Re: Indian Point Unit No. 2  
Docket No. 50-247

Attachment A to this letter provides the additional information requested by members of your staff regarding our February 28, 1985 license amendment application.

Attachment A

INDIAN POINT UNIT NO. 2 COOLANT HEATUP LIMITATIONS  
 APPLICABLE FOR PERIODS UP TO 15 EFFECTIVE FULL POWER YEARS

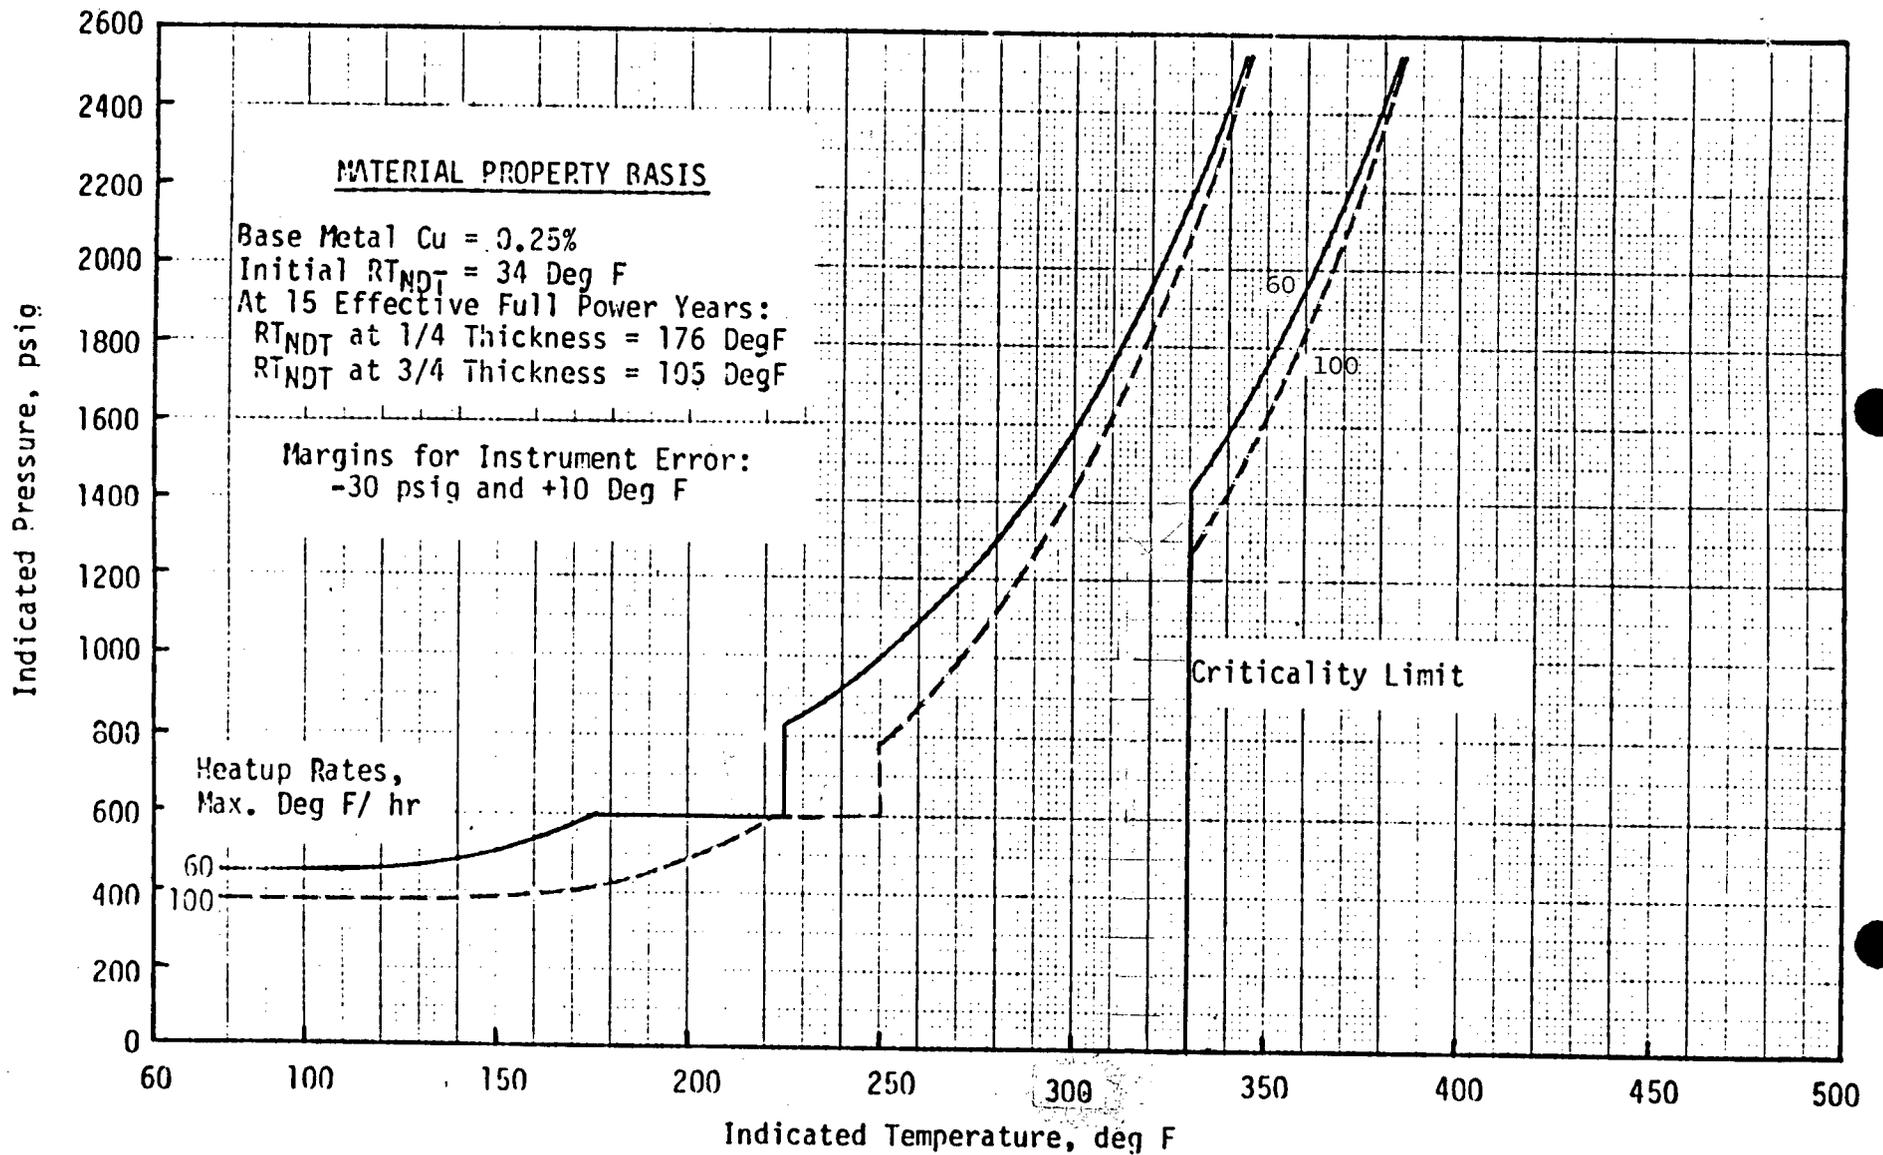
Document the basis for establishing compliance with paragraph IV.A.2 of 10 CFR 50, Appendix G.

In developing the heatup and cooldown curves contained in the February 28, 1985 application, the highest initial  $RT_{NDT}$  of the vessel nozzle shell plates (i.e.,  $25^{\circ}F$ ) was used to determine the limits for the vessel closure flange region to satisfy Appendix G requirements. At the request of the NRC staff, we have investigated the material properties of the flange forgings for the vessel and vessel head. These forgings were manufactured in accordance with ASME A336/Code Case 1332 and, thus, are equivalent to SA-508, Class II, forgings. NUREG-0577 establishes the use of  $40^{\circ}F$  as the initial  $RT_{NDT}$  for SA-508, Class II, material, where specific  $RT_{NDT}$  information is not available. Since initial  $RT_{NDT}$  data is not available for the Indian Point 2 forgings,  $40^{\circ}F$  is to be used. Accordingly, the proposed heatup and cooldown curves have been revised to reflect this more conservative value. These revised figures are attached to this package and supersede the corresponding figures provided in the February 28, 1985 application.
